67 PP

DA (AMENDED)

67 PP
67 Pacific Parade DEE WHY NSW 2099

**BENSON
McCORMACK
ARCHITECTURE**

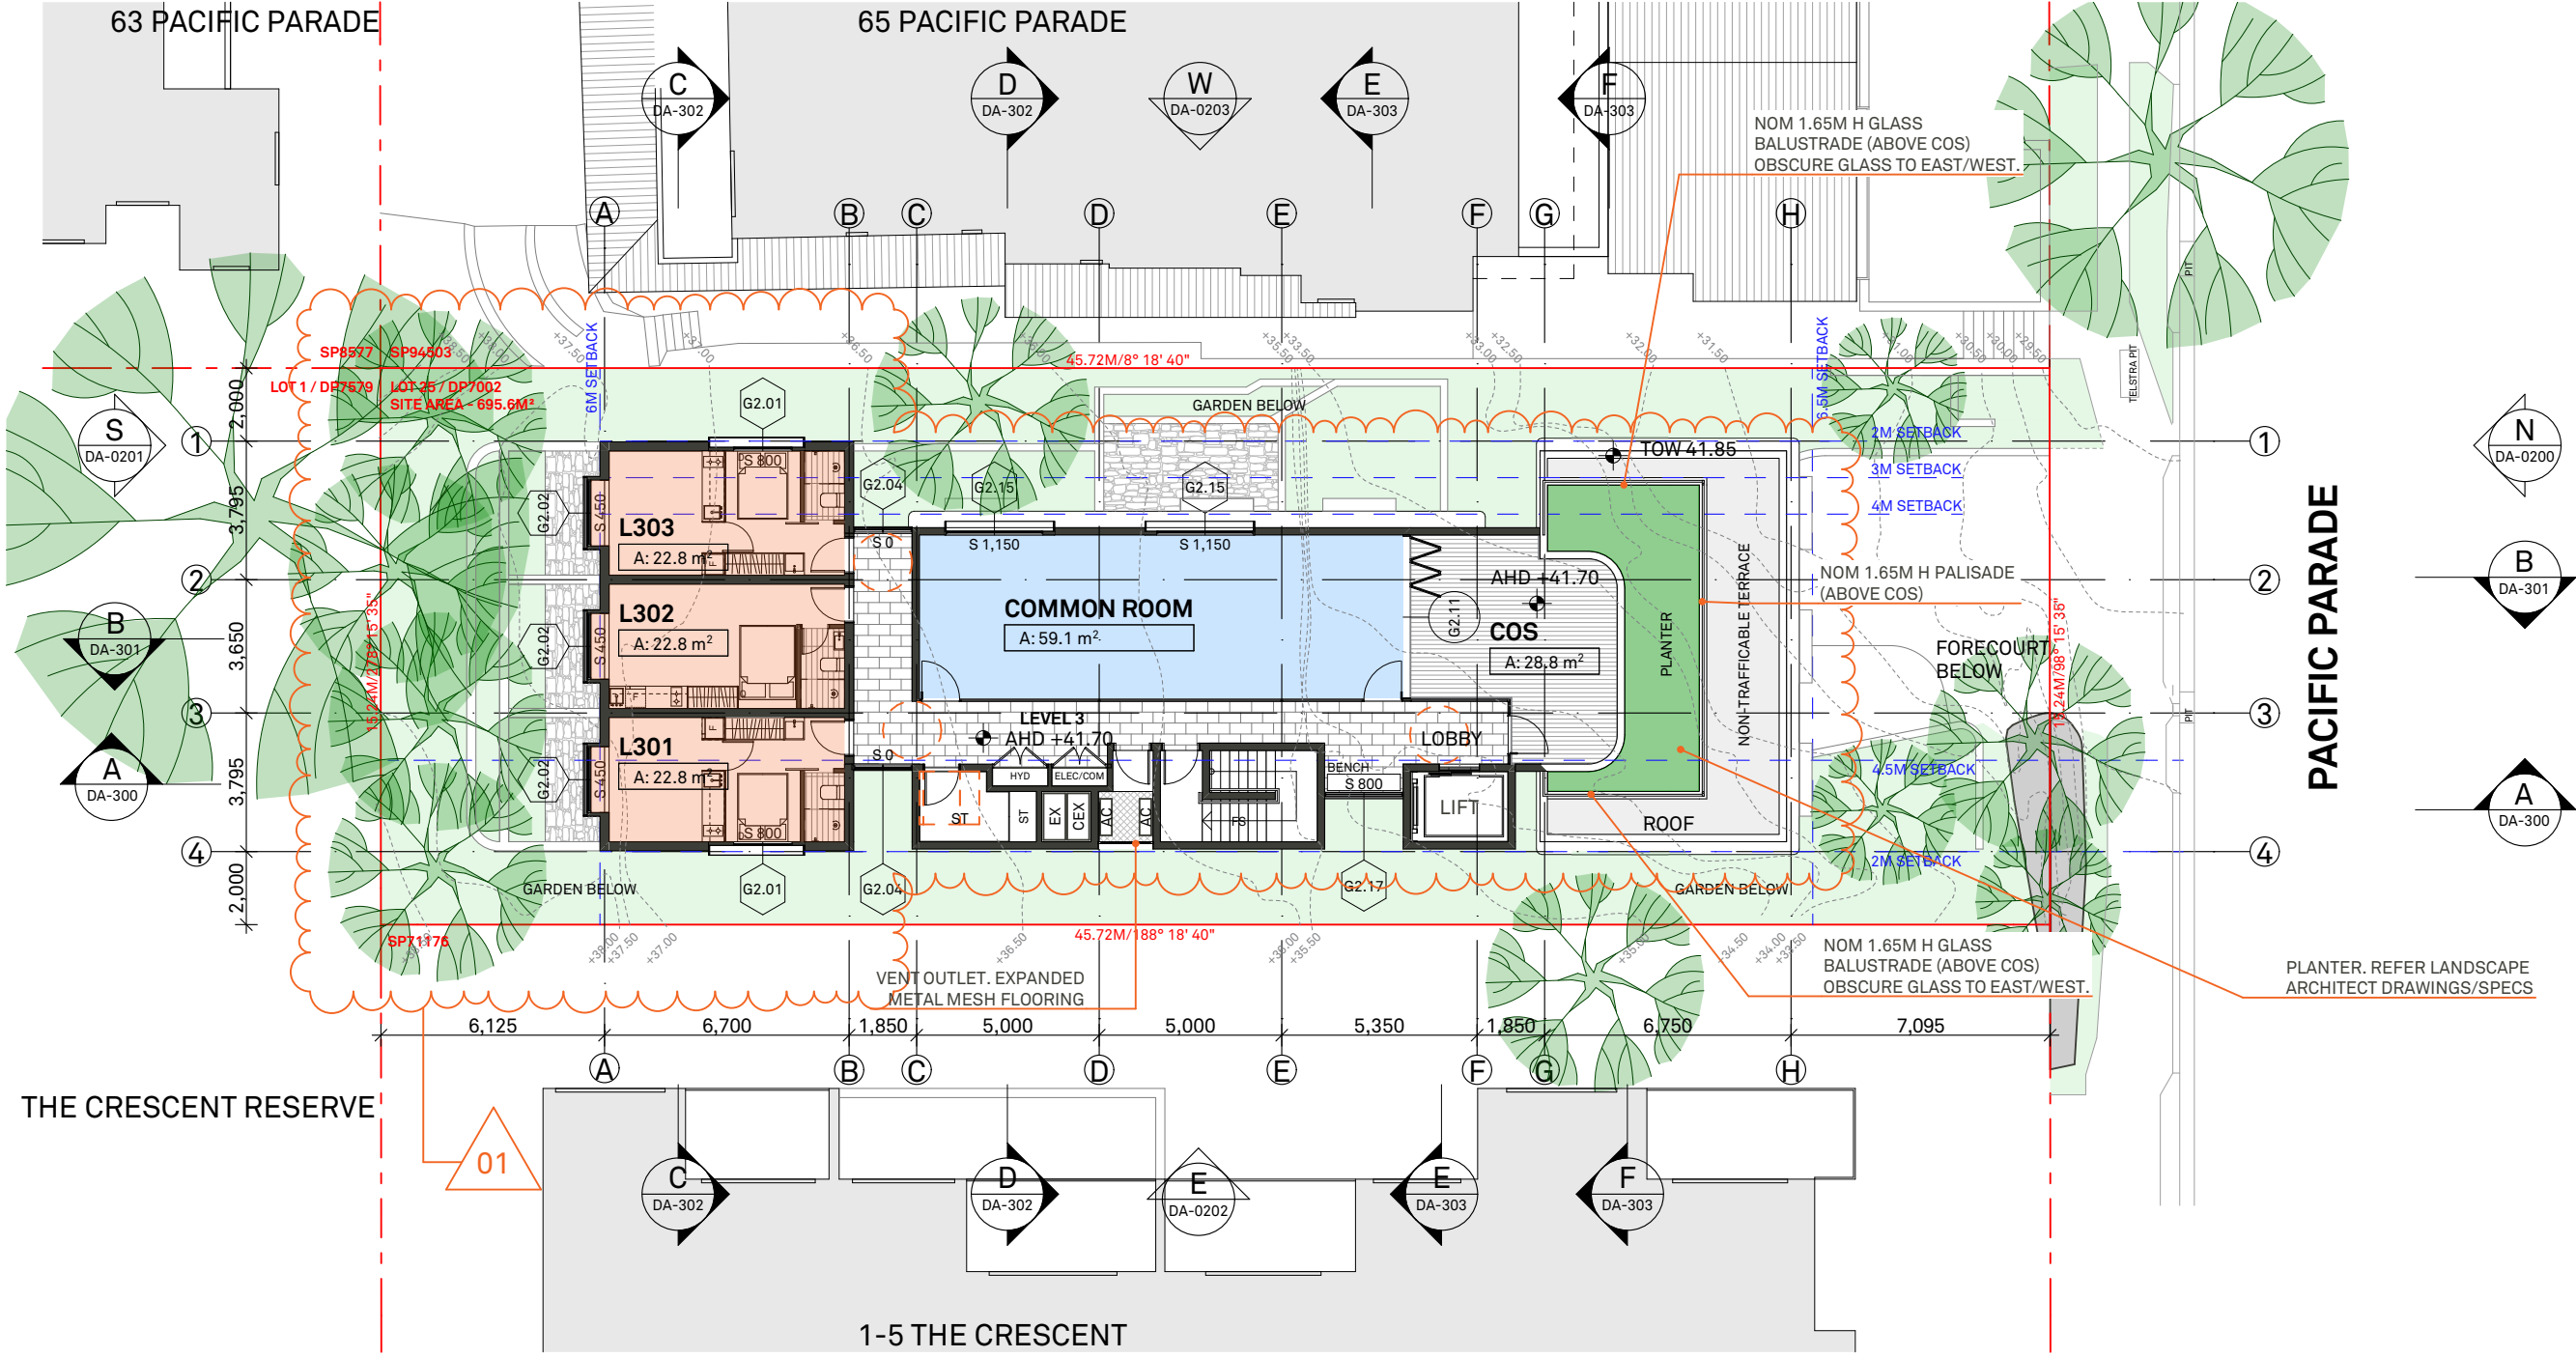
SUMMARY OF CHANGES
01 SHOW PRIVATE OPEN SPACE BELOW;
SHOW AMENDED LANDSCAPED AREAS
BELOW.

CLIENT	PROJECT DETAILS	DRAWING TITLE	SCALE	APPROVED	NORTH
BL 2093 PTY LTD	67 PP	GENERAL ARRANGEMENT - LEVEL 3 PLAN	1:200@A3	GM	
PO BOX 1231	67 Pacific Parade		STATUS	DRAWN BY	
MANLY NSW 2095	DEE WHY NSW 2099		DA	DB	
			PROJECT No	DRAWING No	REV
			2004A	DA-0105	02

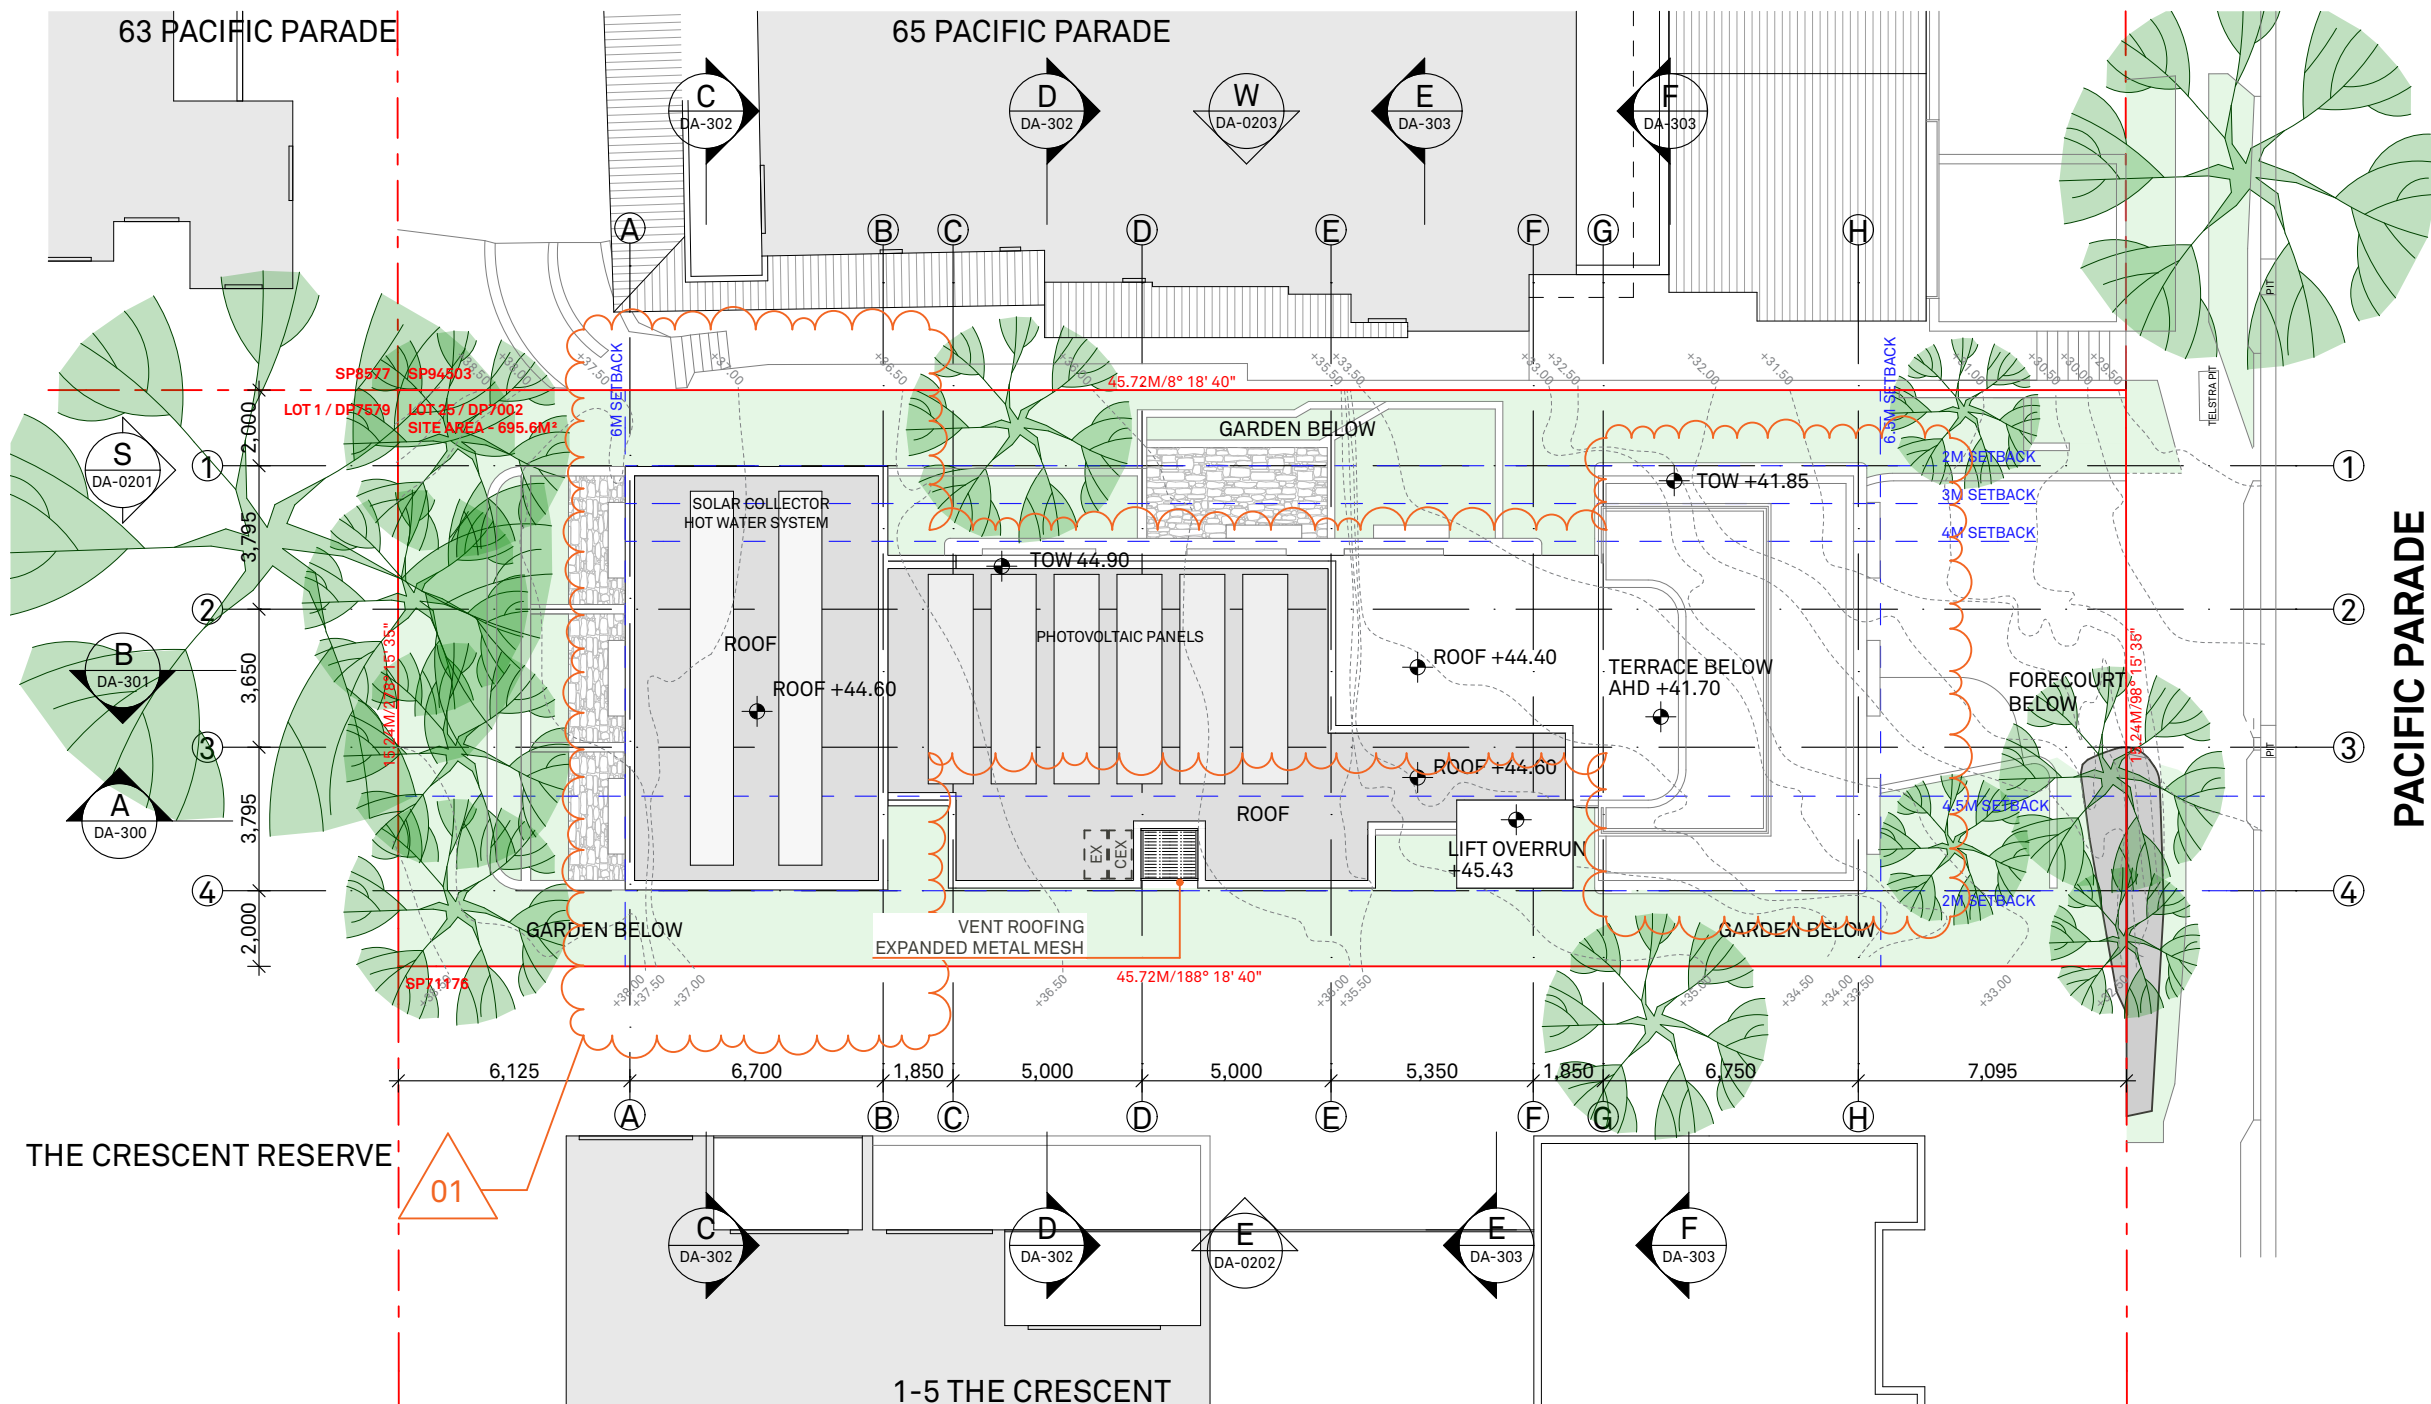
01 CONVERT ROOMS L301-303 FROM TYPE E TO TYPE B (REMOVE LOFT BEDROOMS ABOVE); REMOVE 2x ROOMS; REPLACE WITH LARGER COMMON ROOM; REDUCE AREA OF COMMUNAL OPEN SPACE; PROVIDE PRIVACY SCREENS TO COS

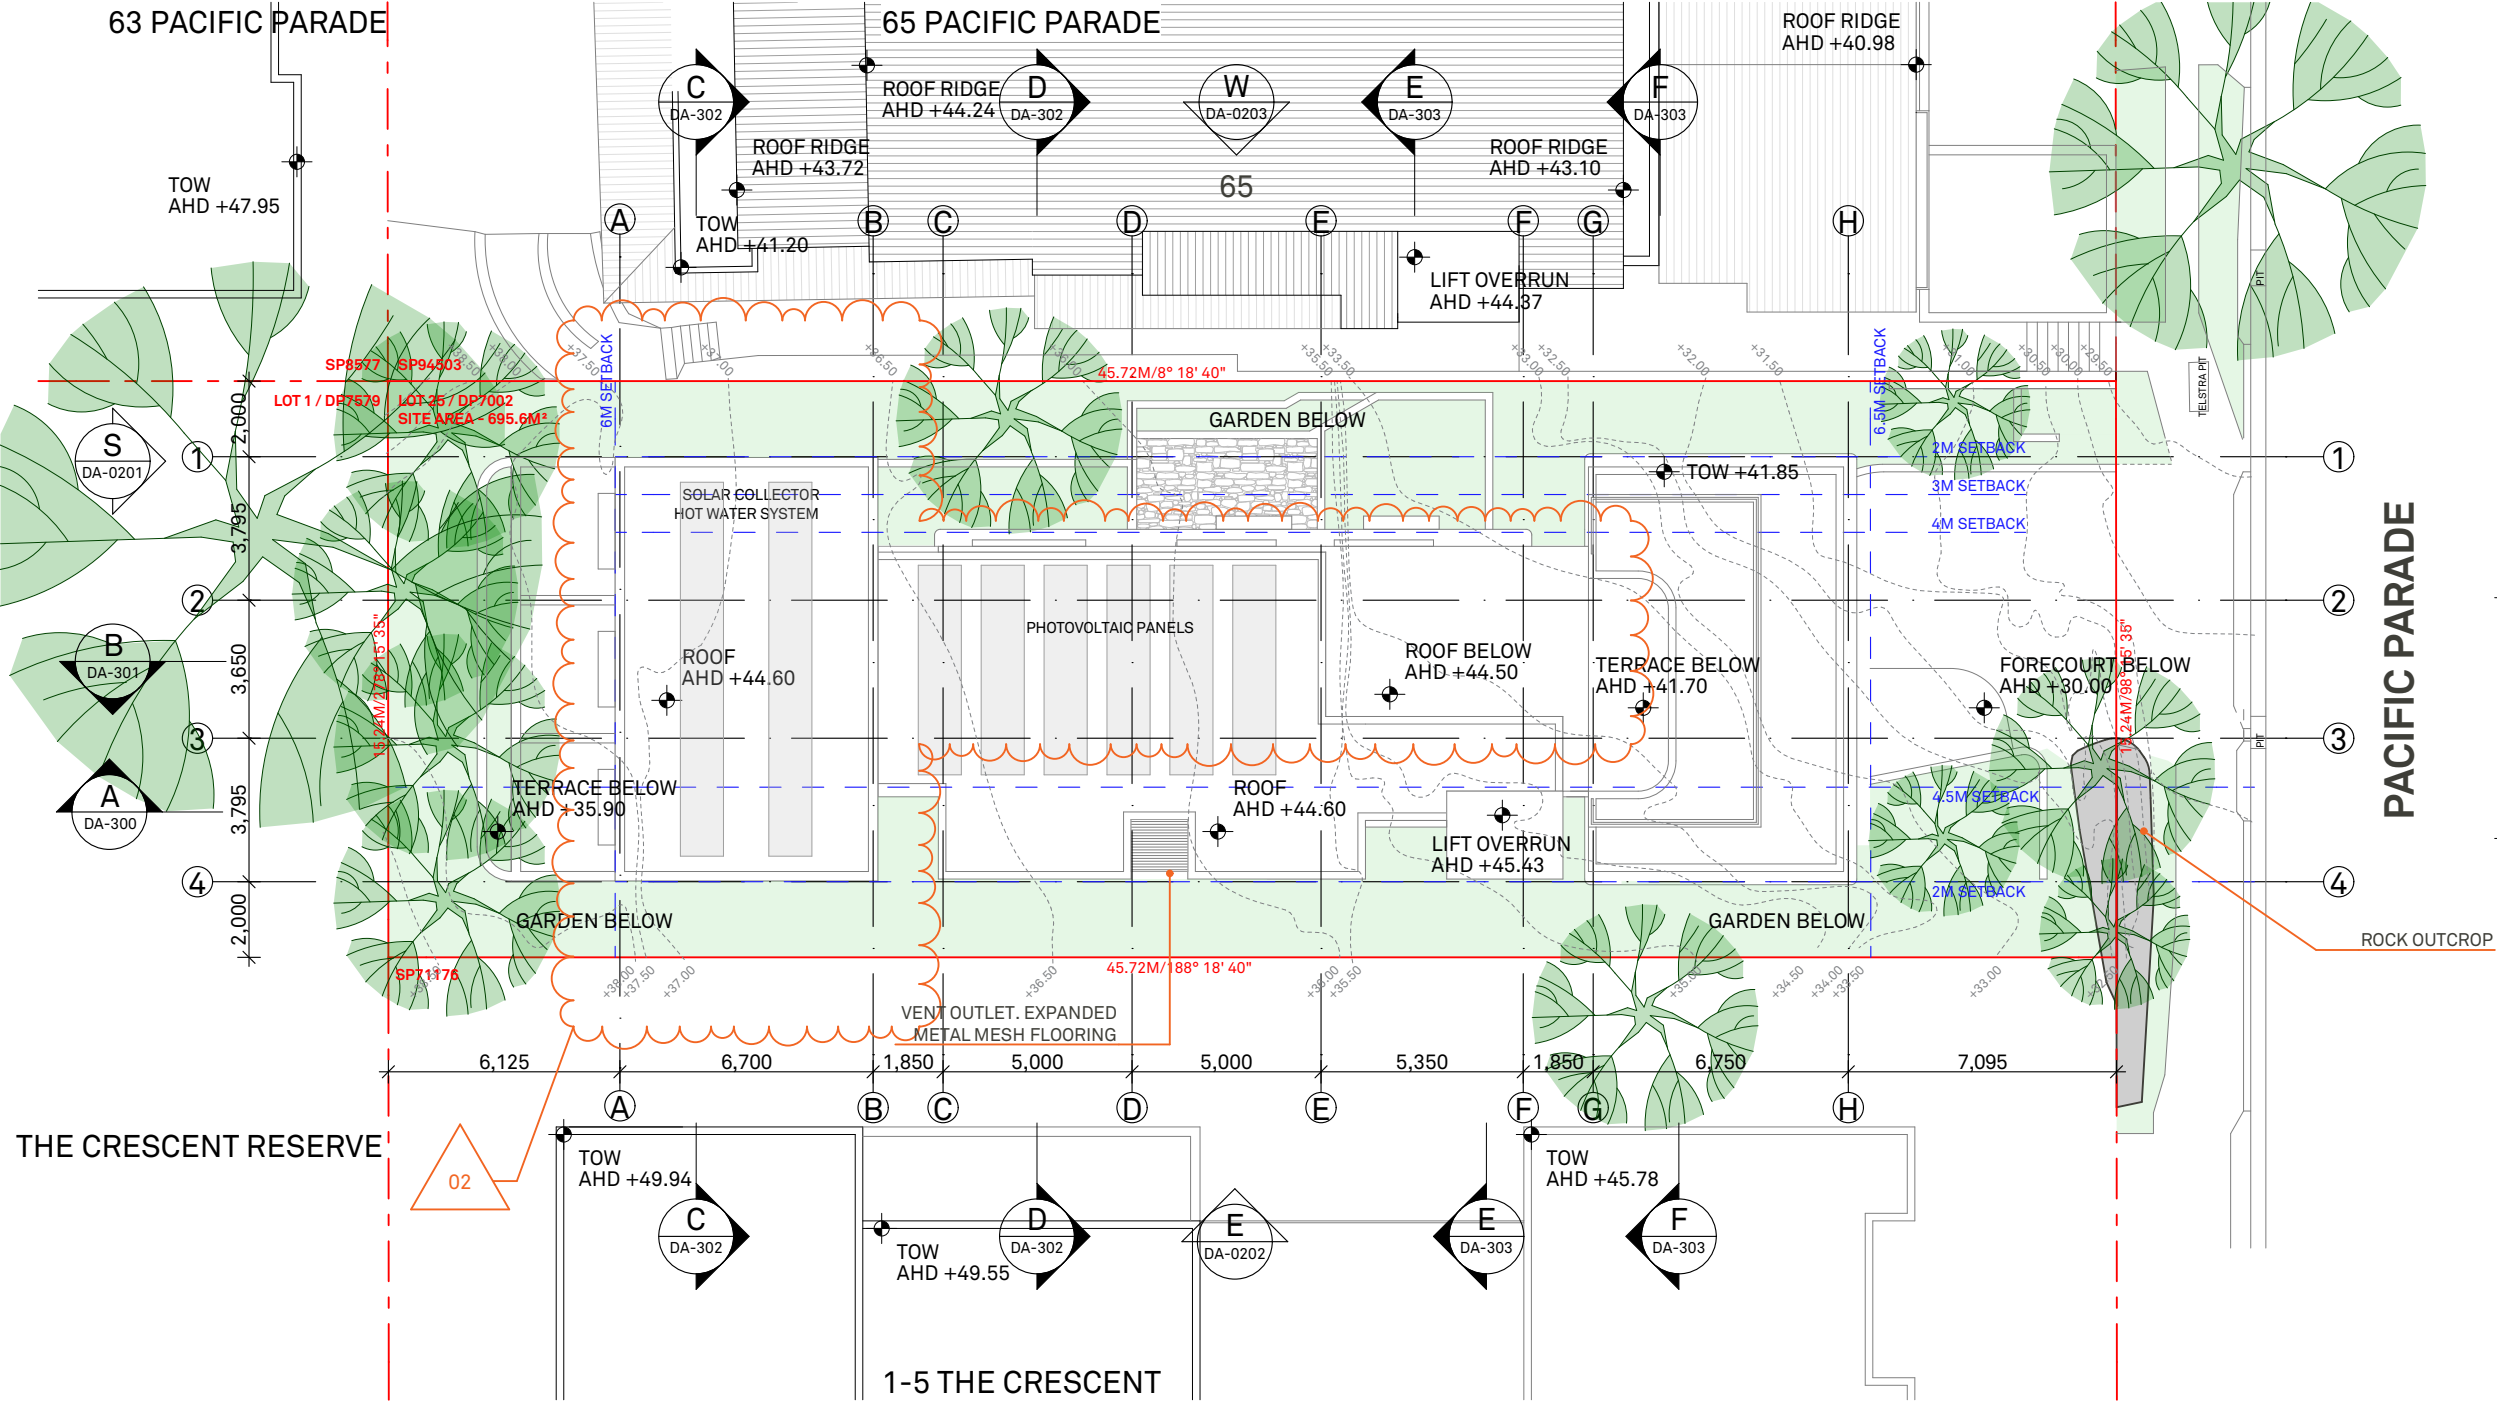
01 CONVERT ROOMS L301-303 FROM TYPE E TO TYPE B (REMOVE LOFT BEDROOMS); REDUCE OVERALL BUILDING HEIGHT; RELOCATE PV'S TO LOWER ROOF (SOUTHERN END)
